CITY OF SUNNYVALE REPORT Planning Commission

August 9, 2004

SUBJECT: **2004-0576** – Fourth Quarter Properties (Partnership Common Names: Forum Development Group, Lehman Brothers and Standard Pacific Homes [Applicant] Target Corporation, WL Partnership, Sun Town Center Properties Corp. (Macy's), Sunnyvale LLC (Mall), and Sunnyvale Redevelopment Agency [Property Owners] application for the redevelopment of 2502 Town Center Lane (Town Center Mall) with a new open-air mixed use shopping district. APN: 209-34-009, 209-34-010, 209-34-016, 209-34-017, 209-34-018, 209-35-001, 209-35-005, 209-35-010, 209-35-011, 209-35-012 and 209-35-007.

Motion: Special Development Permit for site plan, design and use approvals to allow the construction of up to 1,000,000 square feet of commercial space, 275,000 square feet of Office space, and 292 housing units.

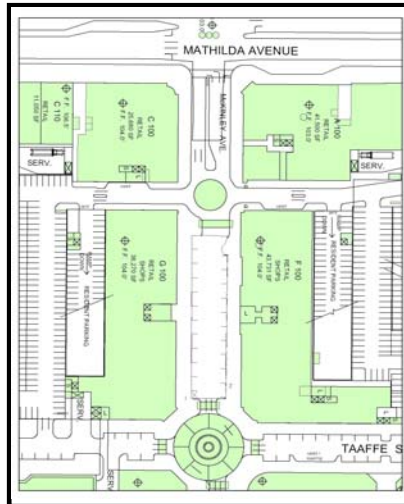
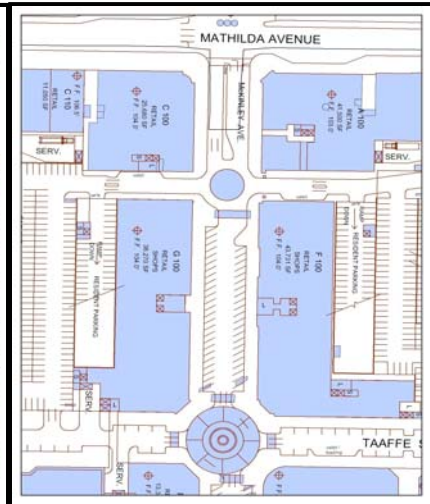
The applicant has proposed angled parking in response to two primary issues, quantity and quality of spaces. Originally the project had angled parking for all streets in the project; in response to staff and other input, the other streets have been modified to parallel parking and parking has been removed completely in front of the Redwood Square. The applicant feels strongly that angled parking should be provided along McKinley Avenue. The applicant argues that angled parking, as compared to parallel parking, is preferred by the merchants, is easier for customers to use, and provides more on-street spaces close to the stores. Angled parking has historically been used in a variety of downtown settings, including Town and Country in Sunnyvale, and downtown Los Altos.

The applicant has provided two schematics to the City on the angled parking layout for the street. The original had a 60-foot curb-to-curb section for parking on both sides and travel lanes, allowing for a typical 20-foot sidewalk. The current proposal of 70-foot curb to curb was submitted in response to maneuvering concerns of the Transportation Division. The current design with parking on both sides has reduced typical sidewalk widths to approximately 15 feet. The applicant would prefer approval of the 60-foot section with wider 20-foot sidewalks based on their experience of design adequacy and preferred pedestrian friendly wider sidewalks.

Furthermore, principles of pedestrian and bicycle friendly design encourage narrower street sections and wider sidewalks; for example the VTA Pedestrian Technical Guidelines call for 10'-11' travel lanes and 16'-18' sidewalks with parallel parking (no bike space) in downtown main street areas. The Transportation and Traffic Manager believes that safe angle parking would necessitate the minimum of 70 feet curb-to-curb, which includes space for bikes. The current plan has provided the 70 feet cur-to-curb with 15-foot sidewalks. Restricted sight lines for drivers also make diagonal parking dangerous for passing bicyclists. Staff believes that diagonal parking with the expanded curb-to-curb width and moderately wide sidewalks will create an automobile-dominated environment, contrary to the goals of the Downtown Specific Plan. Staff is concerned that the amount of pavement, the barrier of

The Bicycle and Pedestrian Advisory Committee viewed the Forum redevelopment plans at its September 18, 2003 meeting. The Committee recommended that angled parking was inappropriate for bicyclists and should be eliminated.

- S1. Revise the site plan to include the following elements:
- 1) Parallel parking along McKinley Avenue
 - 2) Extended movie drop off area across from Redwood Square (may remove parking)
